Access Compliance Report

Public Rights-of-Way

(Curb Ramps)

Intersection ID: 50636	Main Street: BLUE_GROVE_RD	Cross Street: RED_WATER_RD	Location: SE
ADA ID: EA56B9A6E3D1	Ramp Type: Perp	Initial Pass/Fail: Fail	Overall Compliance: No
Codes/Mitigation Info/Possible Solution		Field Measurements/Component Compliance

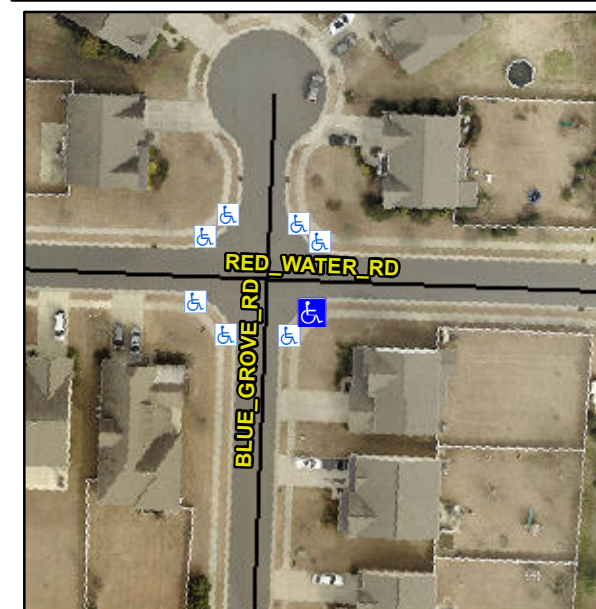
Not Found, R304.5.1, R304.5.3

Compliance	Description	Data	Compliance	Description	Data
N/A	Ramp Length (in)	48.0	Yes	Ramp Slope (%)	7.9
No	Ramp Width (in)	46.5	No	Ramp XSlope (%)	3.3
N/A	Flare Type LT	N/A	N/A	Flare Type RT	N/A
N/A	Flare Slope LT (%)	N/A	N/A	Flare Slope RT (%)	N/A
N/A	Flare Traversable LT?	N/A	N/A	Flare Traversable RT?	N/A
N/A	Landing Length (in)	N/A	N/A	DWS Provided?	N/A
N/A	Landing Width (in)	N/A	N/A	DWS Contrast?	N/A
N/A	Landing Slope (%)	N/A	N/A	DWS Length (in)	N/A
N/A	Landing X Slope (%)	N/A	N/A	DWS Full Width?	N/A
N/A	Landing Curb? (Y/N)	N/A	N/A	DWS Offset (in)	N/A
N/A	Shared Landing?	N/A			
N/A	Gutter Ponding?	N/A	N/A	Gutter Slope (%)	N/A
N/A	Gutter Lip Ht (in)	N/A	N/A	Gutter X Slope (%)	N/A
N/A	Painted X Walk1?	No	N/A	Painted X Walk2?	N/A
	X Walk 1 Direction	To NE		X Walk 2 Direction	N/A
N/A	X Walk 1 Width (in)	N/A	N/A	X Walk 2 Width (in)	N/A
	X Walk 1 Slope (%)	4.6		X Walk 2 Slope (%)	N/A
	X Walk 1 X Slope (%)	0.2		X Walk 2 X Slope (%)	N/A

Remove & Replace Entire Ramp.
